TO: Wyoming Department of Environmental Quality

RE: **Public Comment: Analysis of Impacts to Aquatic Resources**

Small Mine Permit Application-Evans Construction Inc., TFN 7 1/193

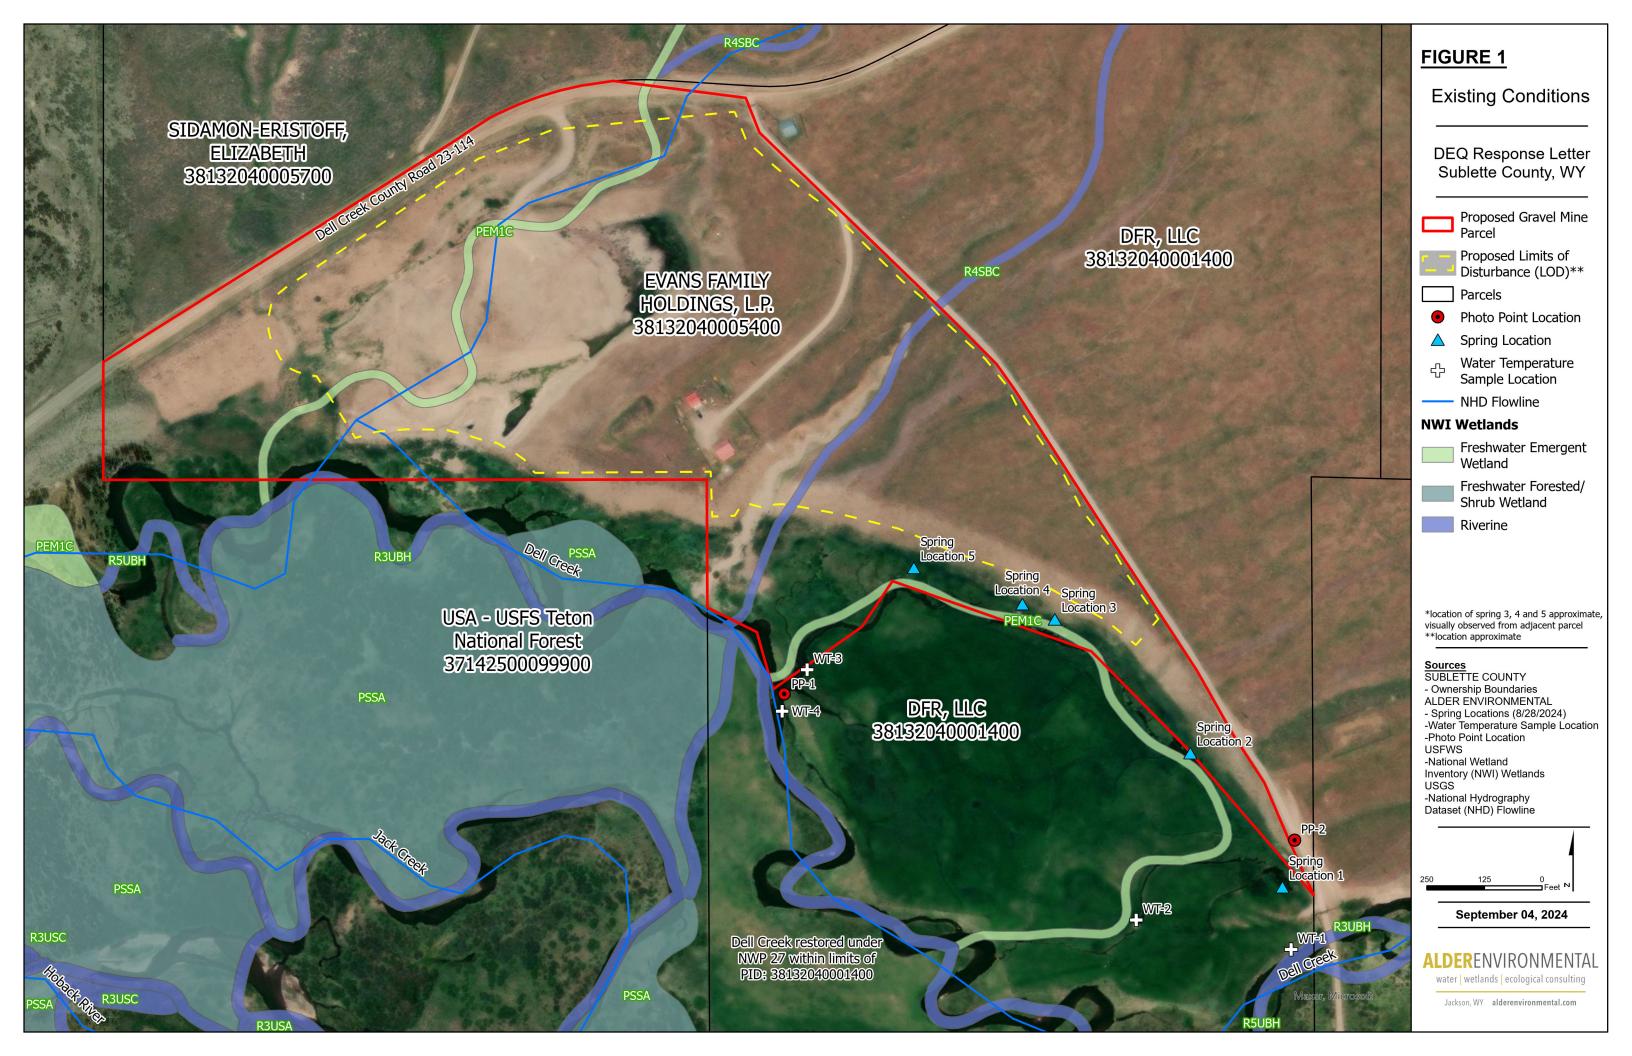
Upon request of the Dawsons, an Alder scientist visited the adjacent parcel (Parcel ID: 381332040001400) on August 28, 2024, to evaluate existing site conditions and potential impacts to aquatic resources. The Alder scientist accessed the adjacent parcel via the shared access road and did not walk on the project property (Parcel ID: 38132040005400). Alder documented the presence of five groundwater springs which have a direct surface connection to Dell Creek and contribute flows to the creek (USGS 2012). As depicted in Figure 1, the location of spring 3, 4, and 5 are approximate and were visually observed from the adjacent parcel. These springs are located along the toe of the bench and were observed to have substantial flows even in dry season (Appendix A-Photo Log). Anecdotal accounts from the landowner indicate these springs run perennially. These accounts and field verification of flow during the dry season contradict the assertation made within the permit application of "seasonal groundwater surfacing at the bottom of the (existing) highwall" (pg. I.F 1). The Alder scientist documented water temperatures of the surface waters near the springs within the adjacent parcel and from the property line. Water temperatures throughout the site ranged from 2-5°C (35.6-41°F). Water temperature sampling locations, approximate locations of the groundwater springs, and additional photo point locations are depicted in Figure 1.
